SUBJECT: SITES WITH EXCLUSION AREAS LESS THAN 0.4 MILES

Re: Proposed Rule on Reactor Site Criteria; Including Seismic and Earthquake Engineering Criteria for Nuclear Power Plants and Proposed Denial of Petition for Rulemaking From Free Environment, Inc. et al. (57 Fed. Reg. 47,802 (October 20, 1992))

**INTERNATIONAL SITING GROUP (ISG)
COMMENTS ON PROPOSED REVISIONS
TO U.S. NUCLEAR POWER PLANT
SITING REGULATIONS**

Figure 13.2 Comparison of individual early and latent cancer fatality risks at all plants (internal initiators).

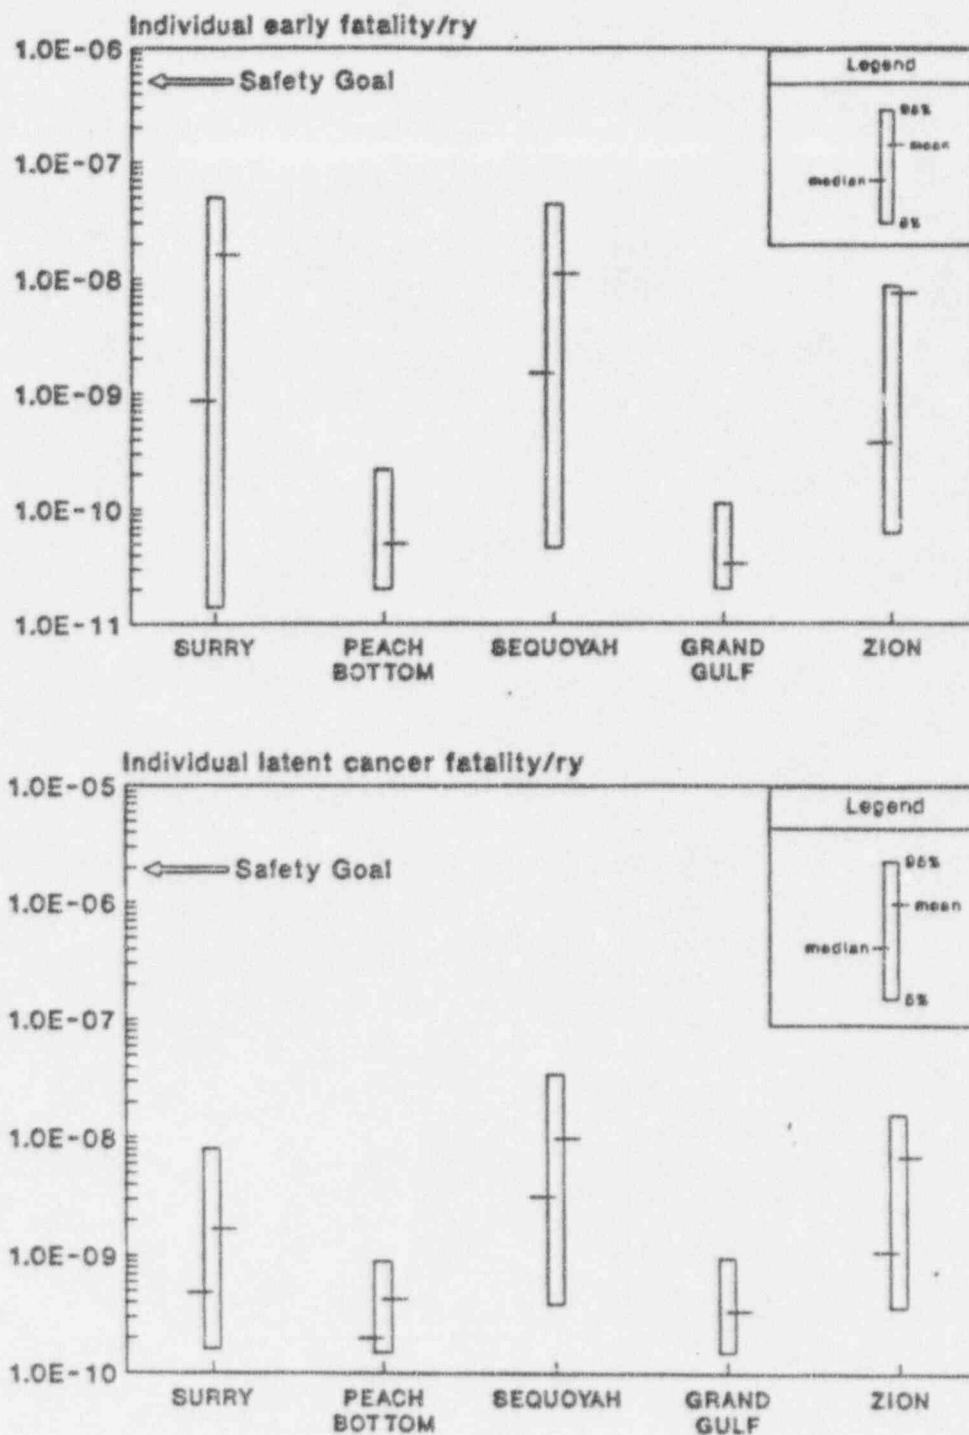
Figure 13.2 of NUREG-1150, reproduced on the next page, demonstrates that the quantitative health effects objectives specified in the Safety Goal Policy Statement

have been met^{24/} and, consequently, that the basic statutory requirement of adequate protection has been met under present (site-plant combination) siting practice.

Of particular interest are the results from one of these five plants, the Zion plant.^{25/} The Zion population density figure is close to the 500 people/square mile value in the proposed rule. As Figure 13.2 shows, the Zion

early and latent fatality risks are quite low and well below the Safety Goals, thus supporting the conclusion that present siting practice has worked well in limiting public risk from nuclear power plant operation. Future plants, with even greater safety capabilities, would show even greater margins. The Severe Accident Policy Statement requires, in effect, that all new plant designs meet certain "fundamental criteria" to reduce severe accident risk and that cost-effective features of a preventive or mitigative nature be included in the design. The Safety Goal Policy Statement provides guidance in determining cost-effectiveness. Taken together, these two policy statements ensure adequate protection of the public health and safety and a very low level of residual risk.

FIGURE F9.14

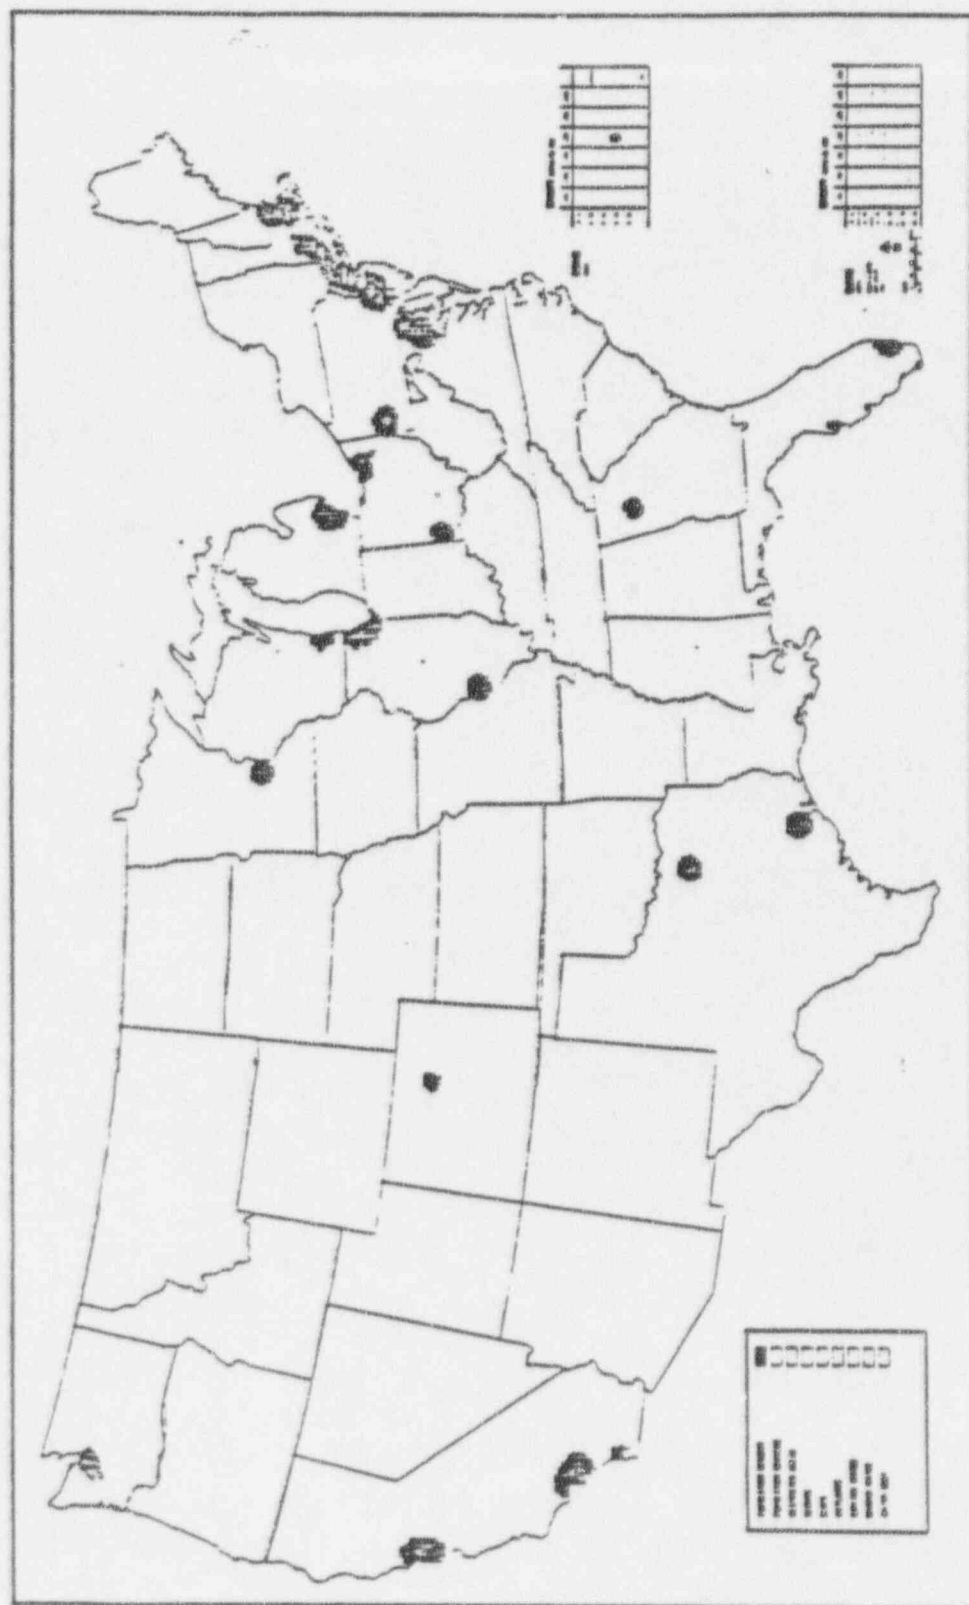
The risk reduction benefit from codification in Part 100 of the demographic limits in Regulatory Guide 4.7 (Rev. 1) would not outweigh the potential for elimination of superior sites. Risks (the product of the probability of an event times the consequences from the event should it occur) are already very low, as discussed above. This inherently precludes further risk reductions that are substantial. However, the proposed rule discusses consequences as well as risks.

Even if probability is not taken into account -- an inherent regulatory deficiency -- the proposed rule would not provide any significant reduction in early injury or early fatality consequences. Additionally, the proposed rule, if adopted, would result in only a very limited potential decrease in latent fatality consequences.
